CEC Data Request #2 - Cultural and Tribal
Cultural Resources Response

Potentia-Viridi Battery Energy Storage Project

MAY 2025

FIGURE 4

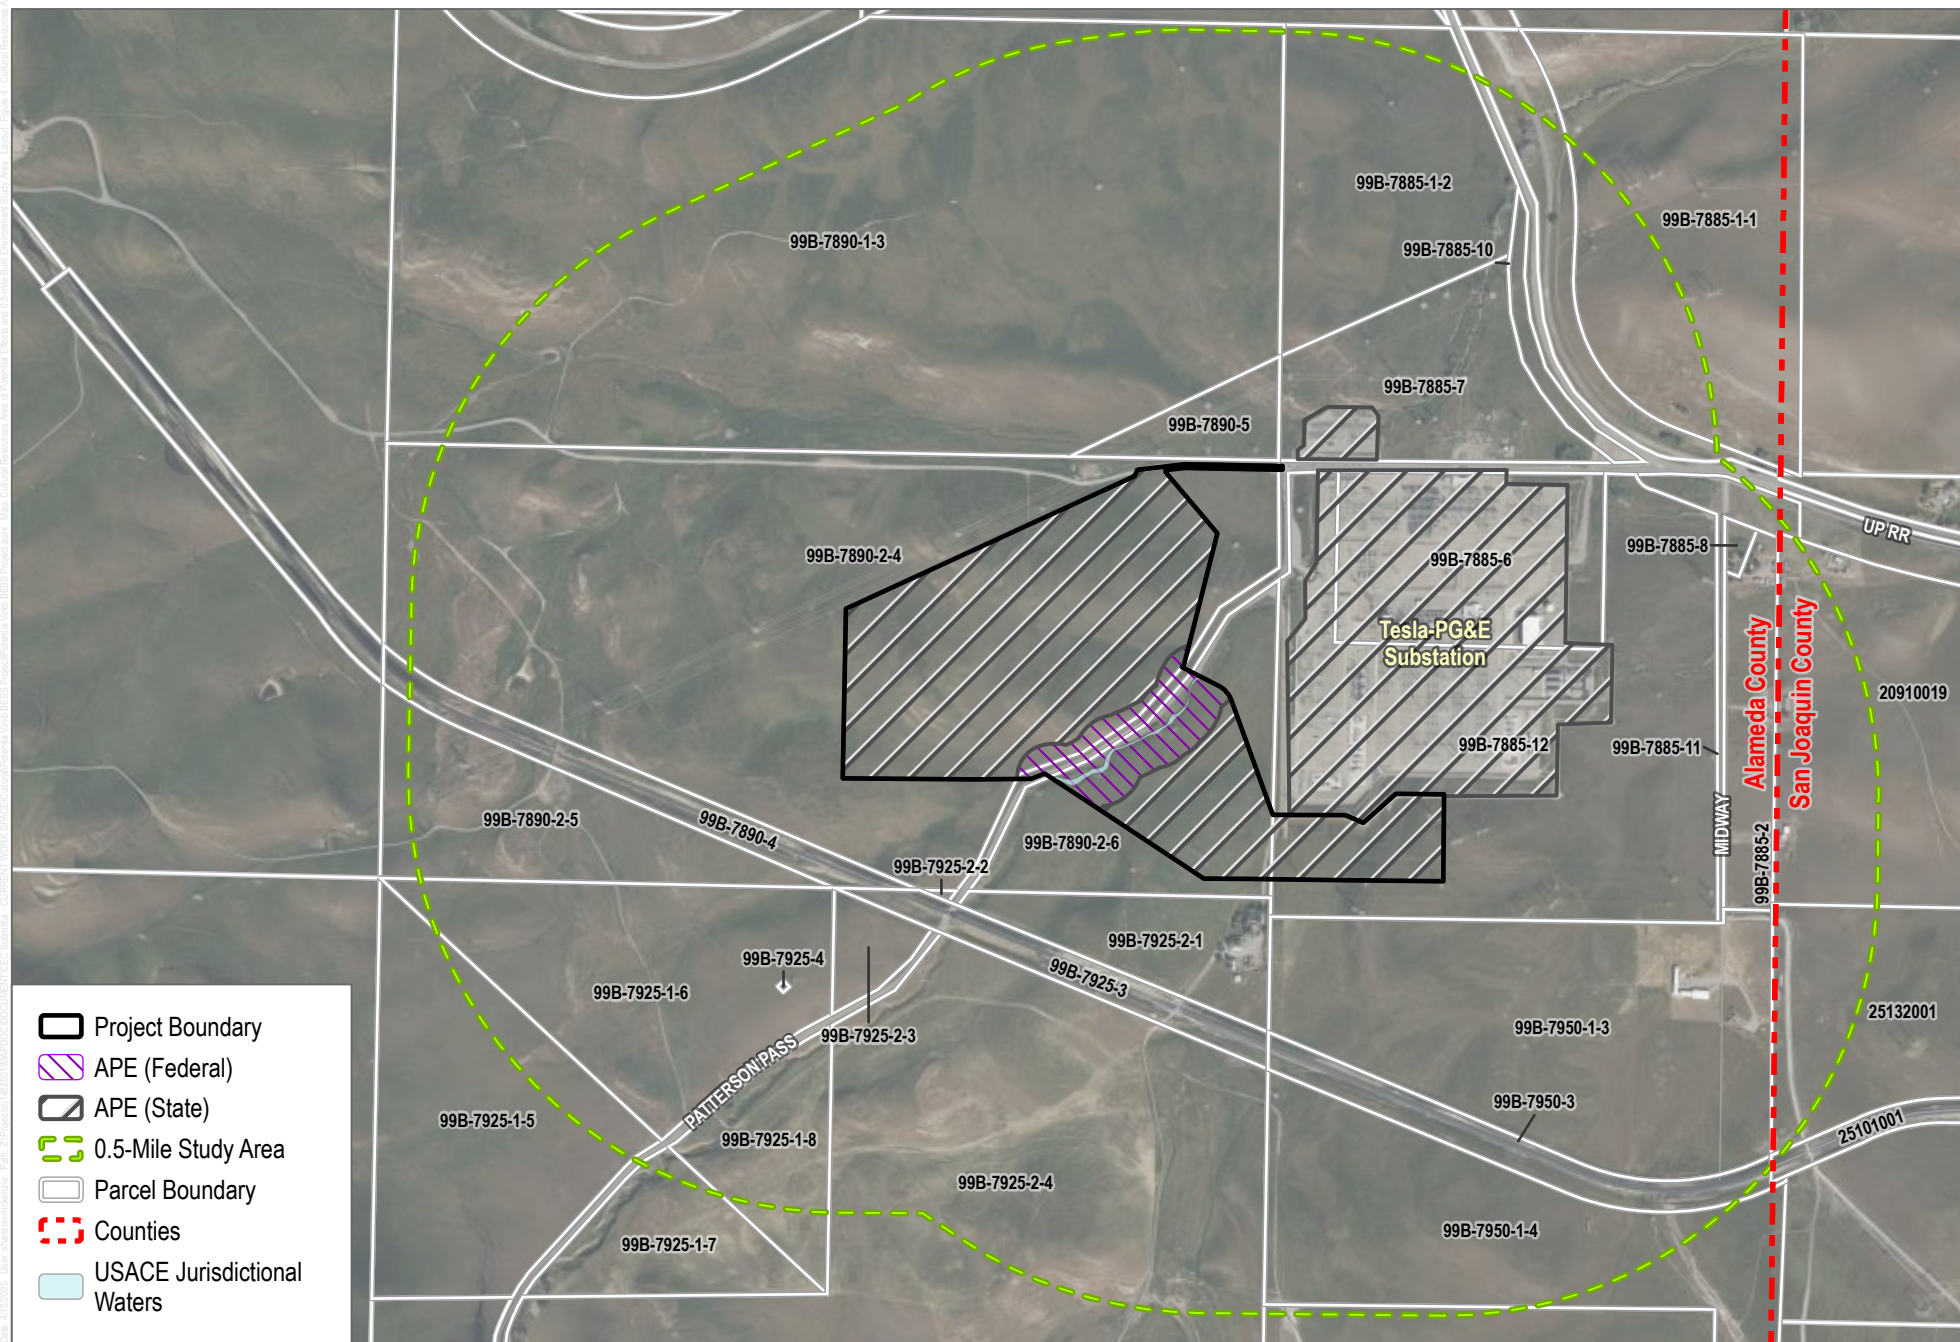
REV DR CUL/TRI-5. *Please prepare a figure showing the boundaries of the historic architecture field survey conducted by the applicant's consultants. The historic architecture field survey should be no less than 0.5 miles out from the proposed project site and from routes of all above ground linear facilities (Cal. Code Regs., tit. 20, Appendix B (g) (2) (C)).*

Response: Figure 4, Cultural Resources Area of Potential Effects and 0.5-mile Built Environment Study Area is included as Attachment 3 and includes the requested information.
